SPECIFICATION REVISIONS
REVISION TO STANDARD SPECIFICATIONS

PROPOSAL TO STANDARDS COMMITTEE

REVISION TO STANDARD SPECIFICATIONS
SECTION 725 - SLIP LINING OF EXISTING PIPE

723-CCSP-01 THREE-SIDED CONCRETE CULVERT SCOUR PROTECTION

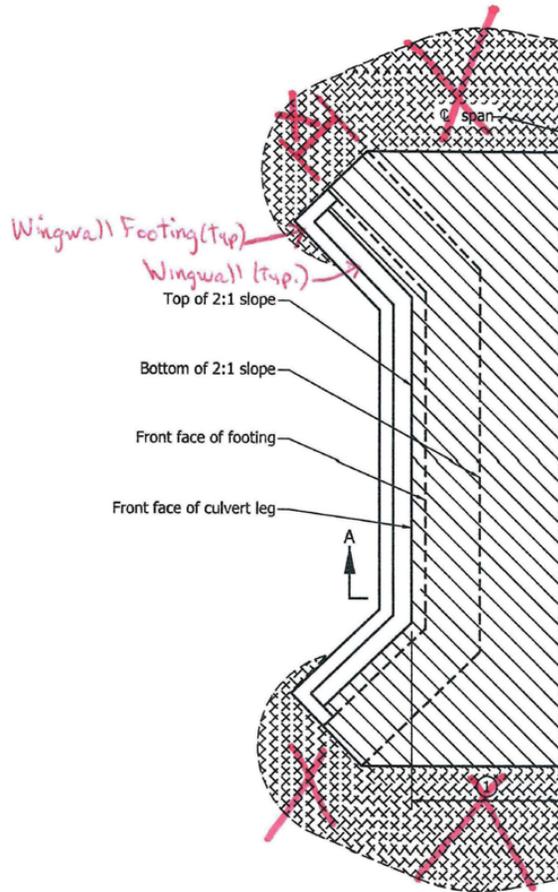
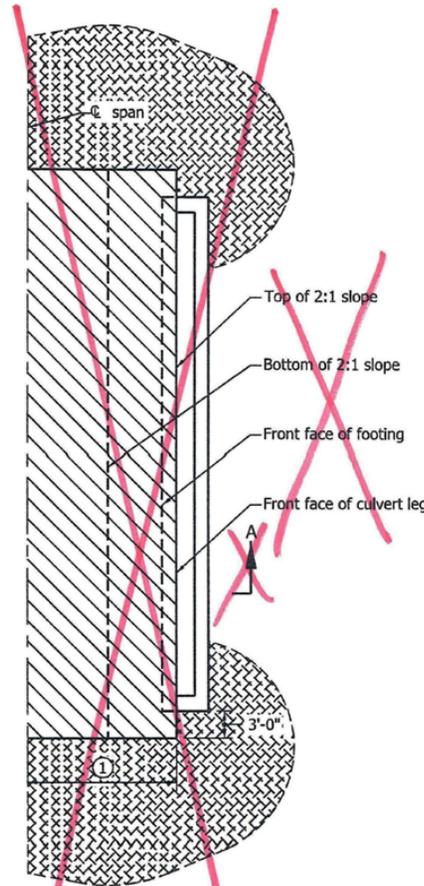
Delete the projecting option as shown in the attached Standard Drawings.

706-BRRW-07 RAILING TYPE FC AND MOMENT SLAB ATOP MSE WALL - HMA PAVEMENT

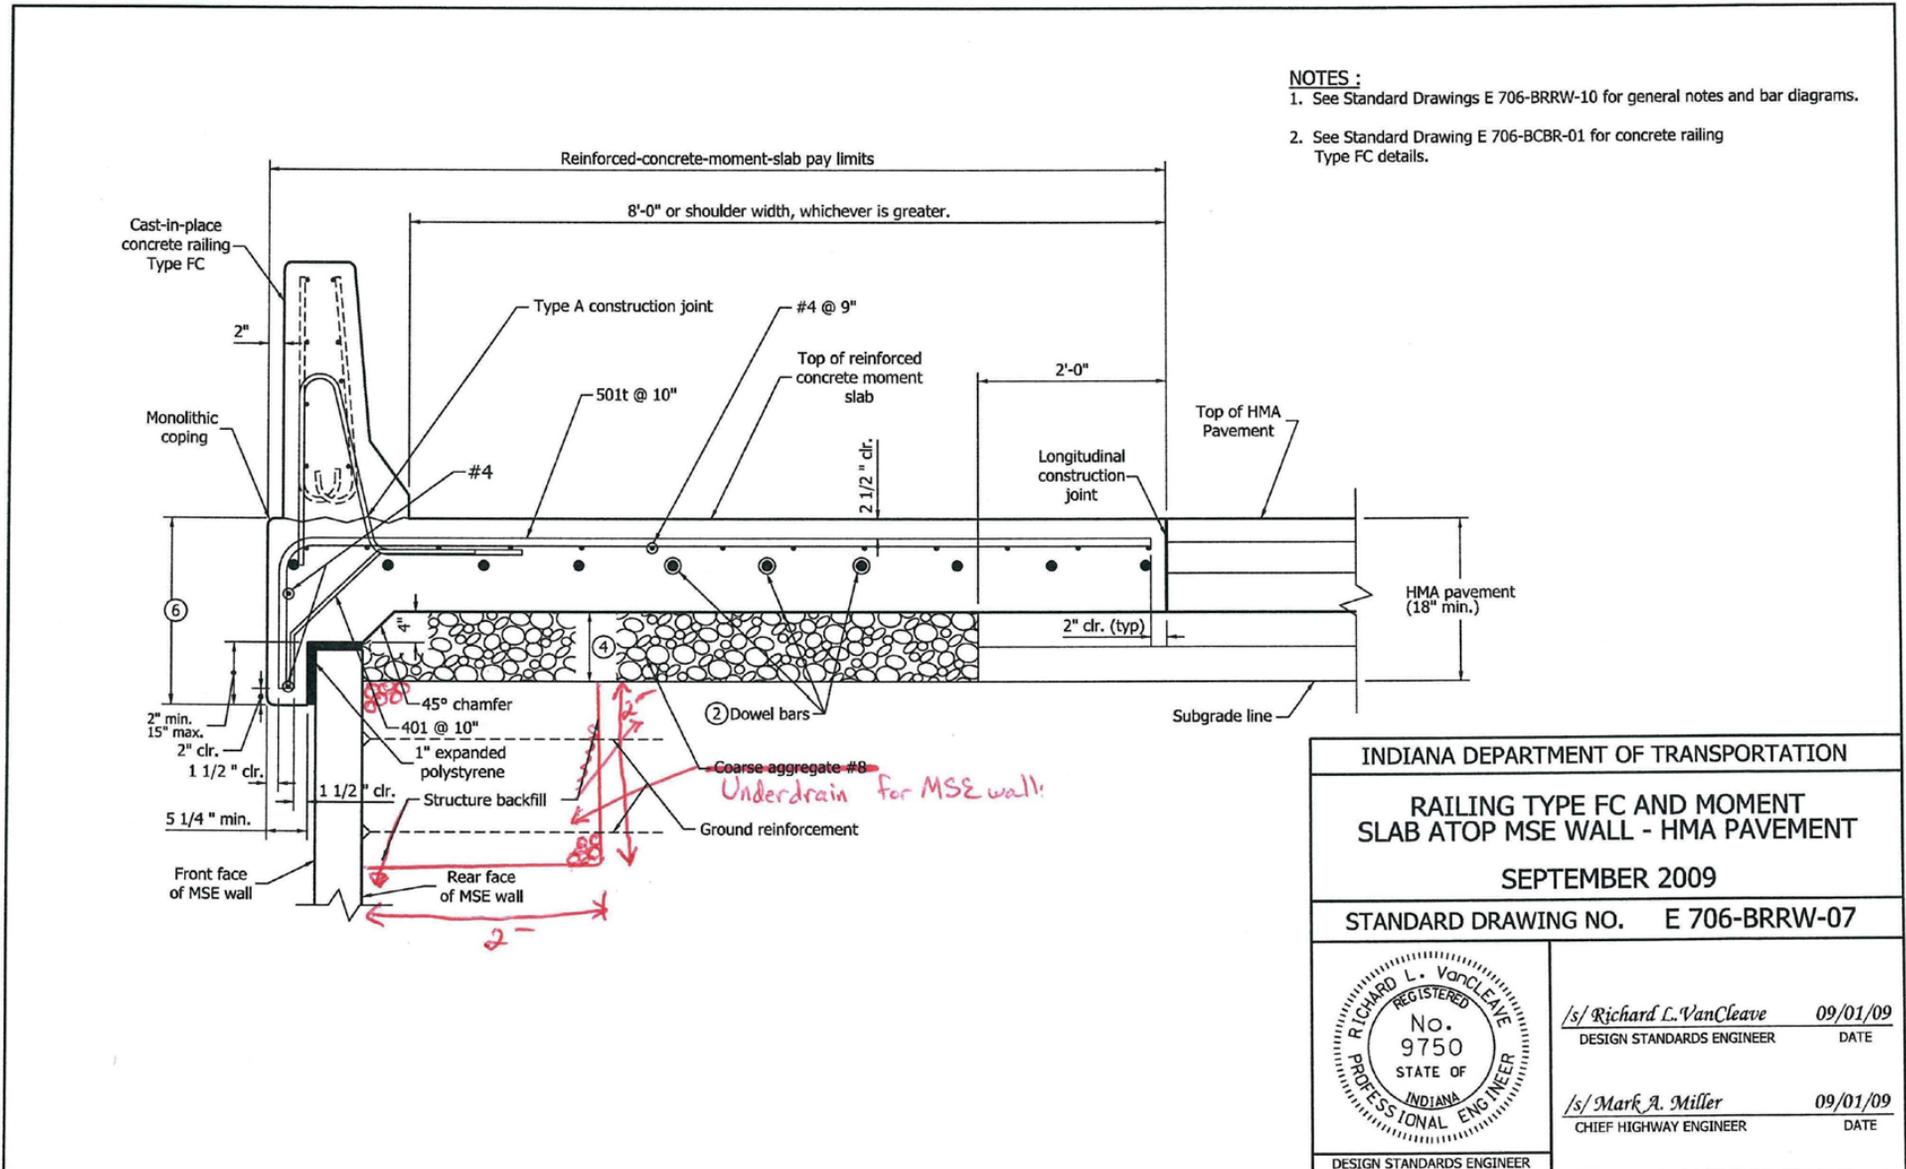
PROPOSED SOLUTION: Modify the typical underdrain detail to provide subsurface drainage for pavement sections when located within MSE wall limits.

- ③ The coping by be precast or cast in place. See Standard Drawing E 731-BRRW-01 for coping details.
- ④ The thickness of the ~~coarse aggregate No. 8~~ ^{Underdrain For MSE wall} shall be equal to the combined thicknesses of the first two lifts of HMA, but not less than 6 in.

REVISION TO 503-CCPJ-02 LONGITUDINAL JOINT

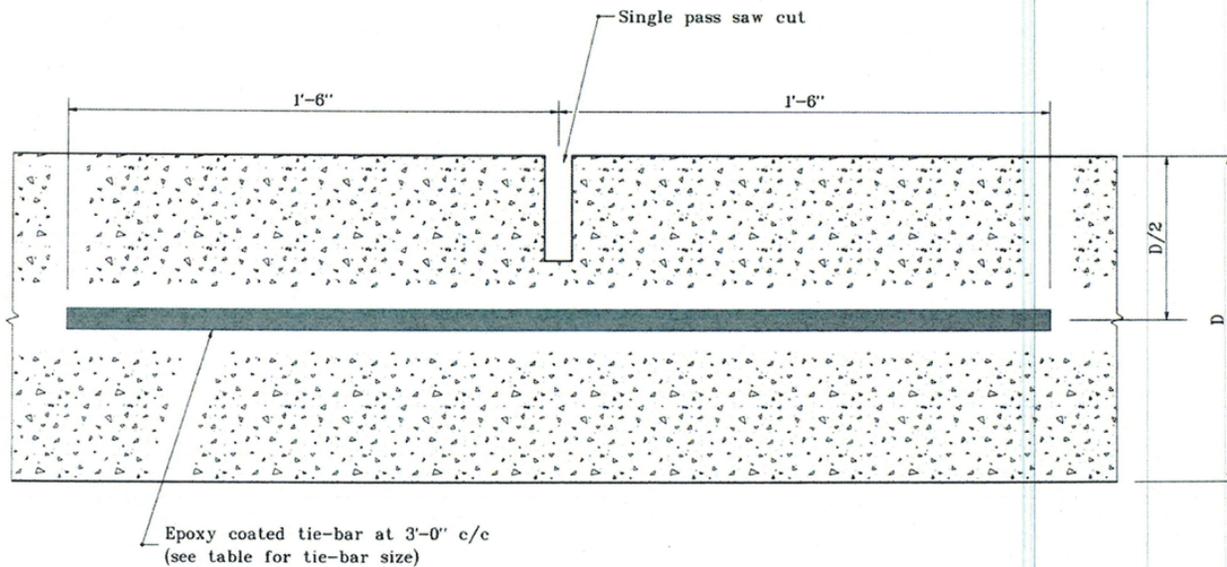
Standard Drawing E 503-CCPJ-02 tie bar sizes are not in accordance with MEPDG.
Standard Drawing E 503-CCPJ-08 retrofit tie bar sizes are not in accordance with MEPDG.
Standard Drawing E 506-CCPP-01 retrofit tie bar spacing for patches is in error. The drawing has tie bars spaced at 6 inches for a 6'-0" patch, referenced Standard Drawings are in error, and editorials.

Standard Drawing E 503-CCPJ-02 - Revise tie bar sizes.
Standard Drawing E 503-CCPJ-08 - Revise retrofit tie bar sizes.
Standard Drawing E 506-CCPP-01 - Revise retrofit tie bar spacing, correct references, and make editorial revisions.

TIE-BAR SIZES FOR LONGITUDINAL JOINT	
Pavement Thickness, D	Tie Bar Size
Less than 9" <i>or equal to</i>	#5
9" through 12"	#6
Greater than 12" <i>9"</i>	#7 <i>#6</i>

PROPOSED NEW STANDARD DRAWING 709-SSBP-01 SURFACE SEAL IN BRIDGE-STEEL-PAINTING PROJECT (DRAFT)

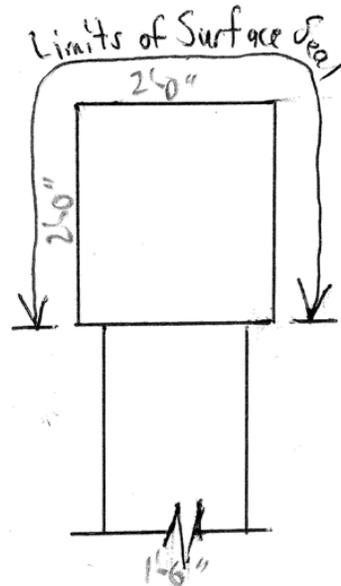
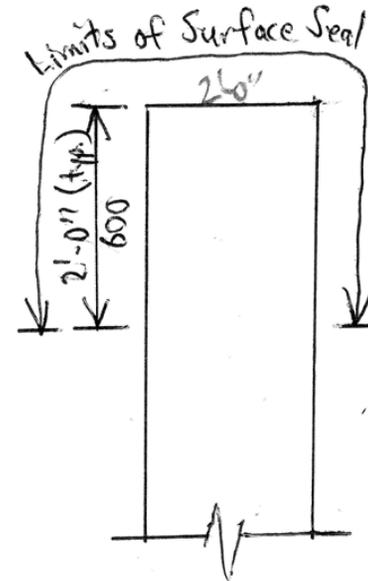
709-M-019 SURFACE SEAL FOR BRIDGE TO BE PAINTED
 NEW STANDARD DRAWING 709-SSBP-01 SURFACE SEAL IN BRIDGE-STEEL-PAINTING PROJECT
